HISTORIC PRESERVATION COMMISSION

SUBJECT: Historic Area Work Permit # 867436 REVISION #4: Basement Areaway and Entrance,
Porch Flooring, and Door Revisions.

Applicant: 19501 Georgia LLC (Luke Olson, Agent)
Address: 19 High St. (Parcel 700), Brookeville

**19 HIGH ST
LOT 4**

2 REAR DECK DETAIL
SCALE: ???

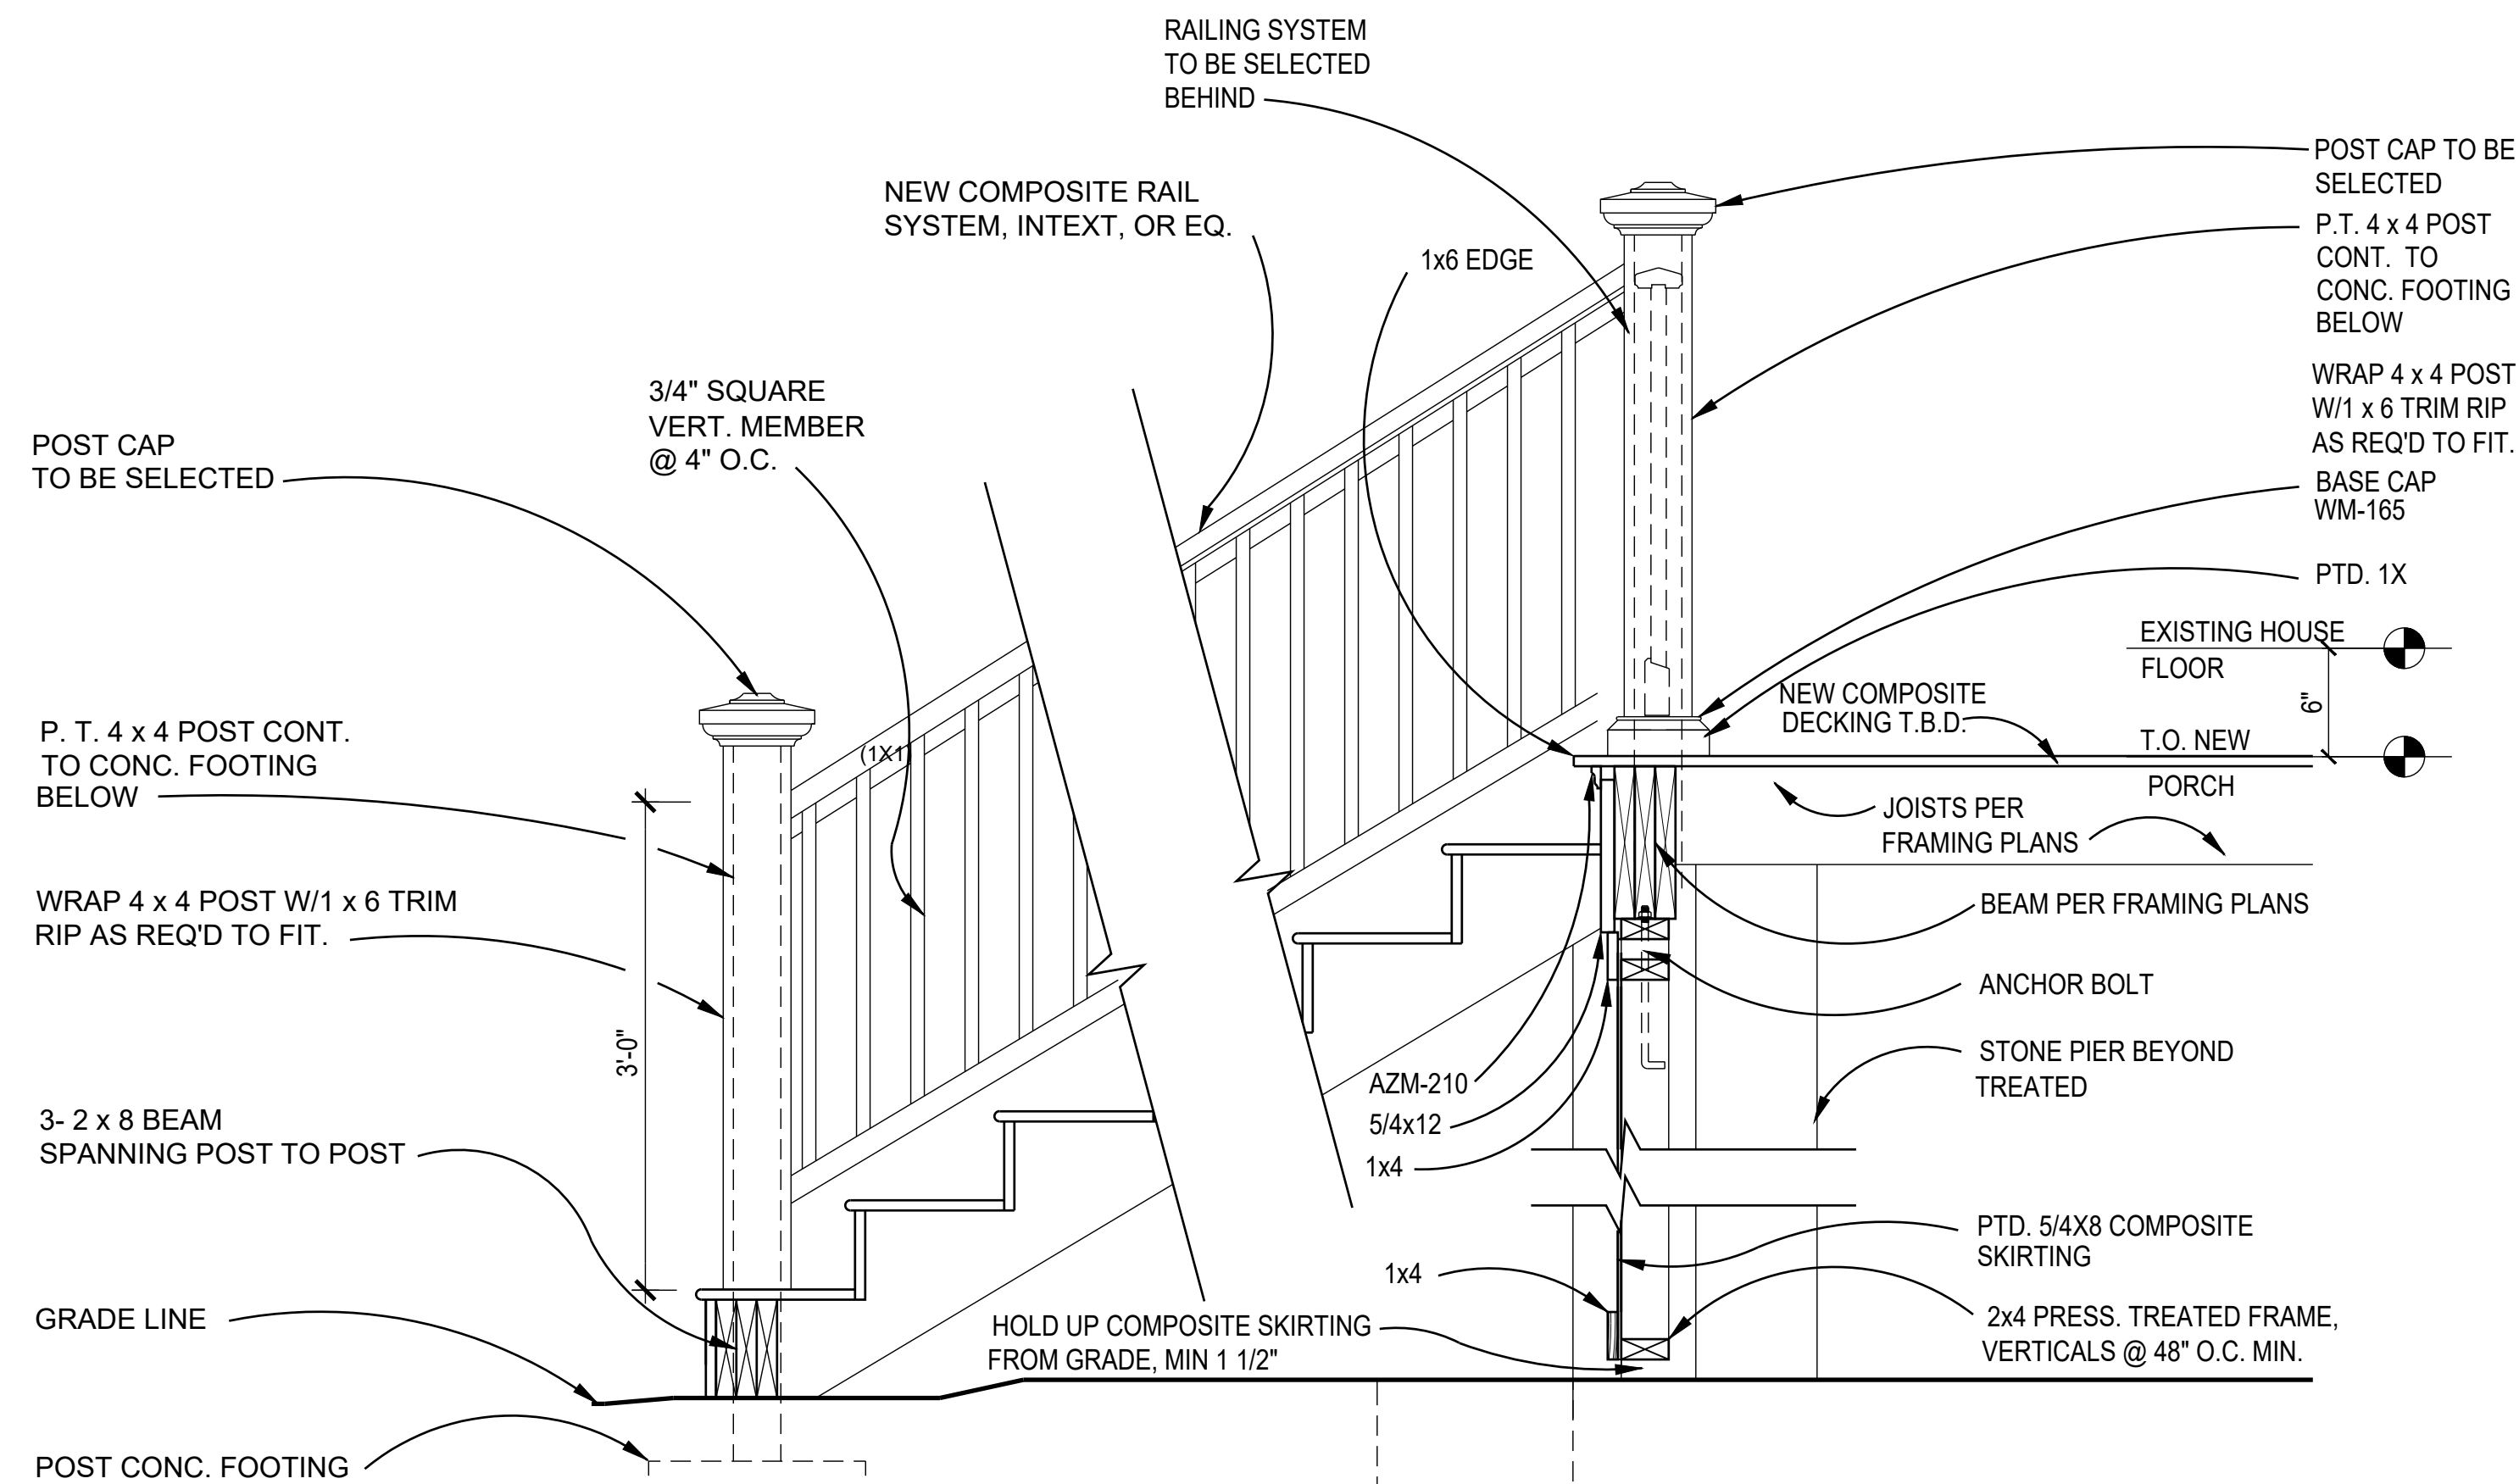
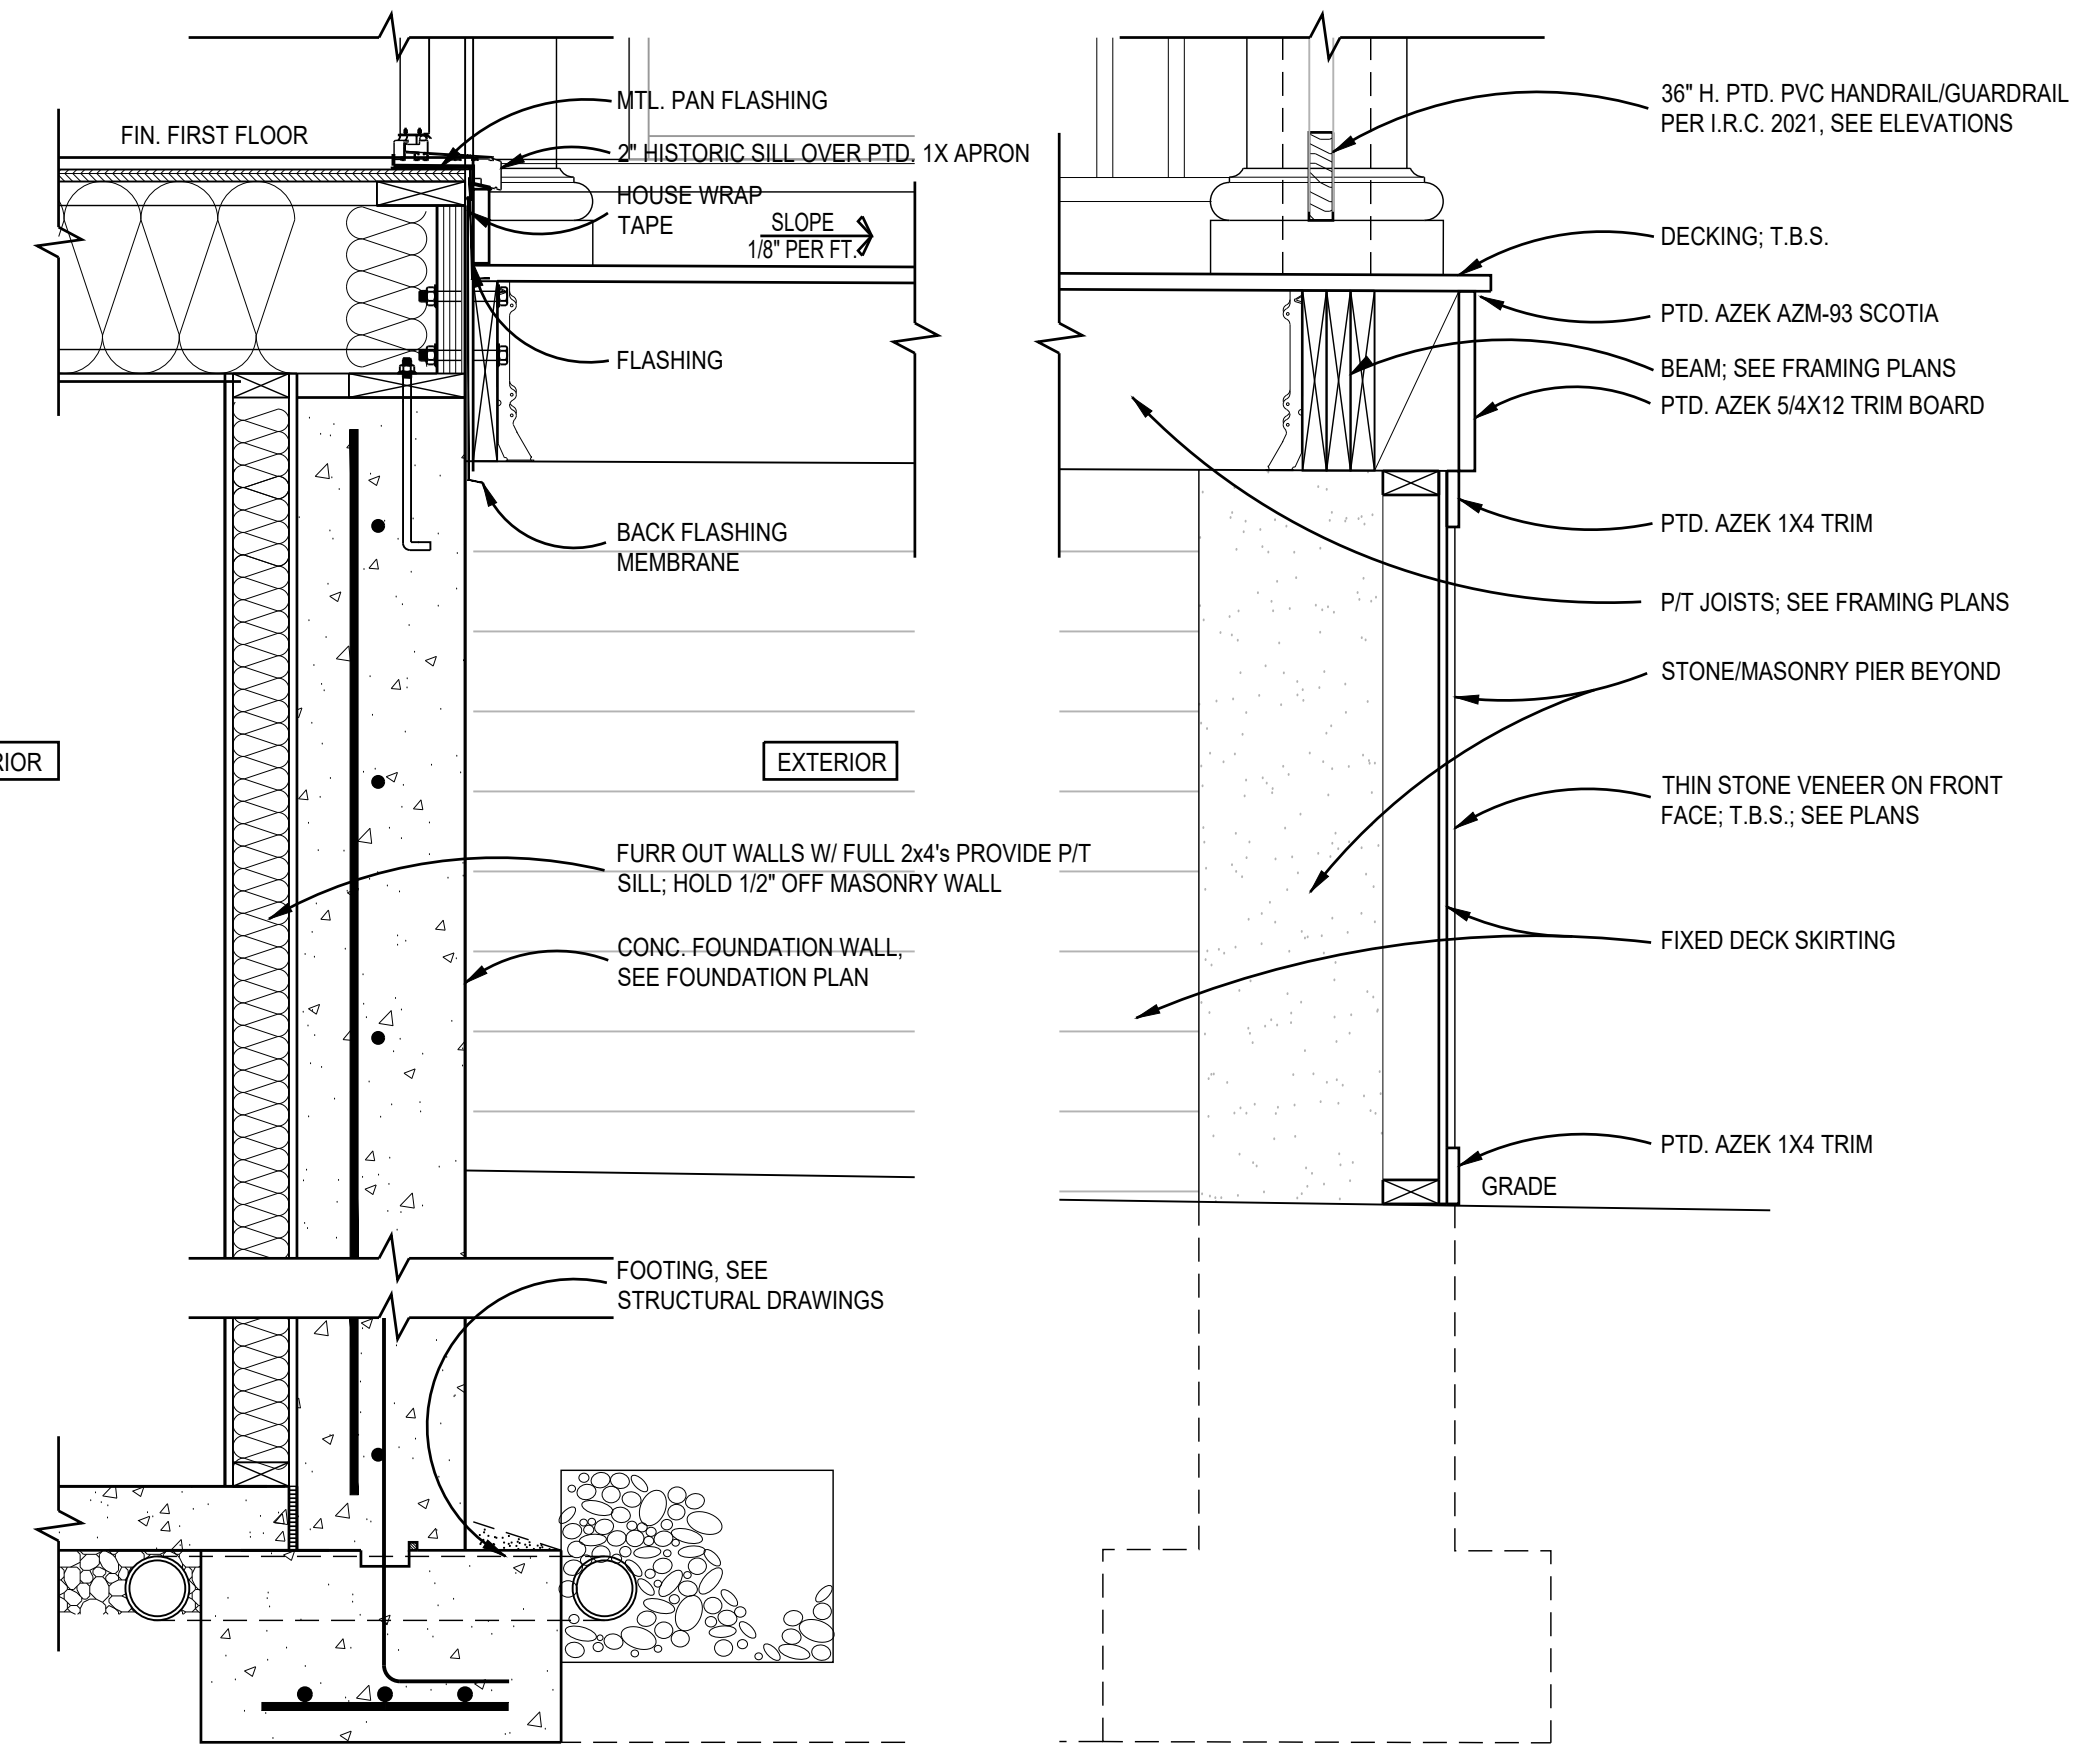
ATTACHED DECK FLASHING DETAIL
Figure 15
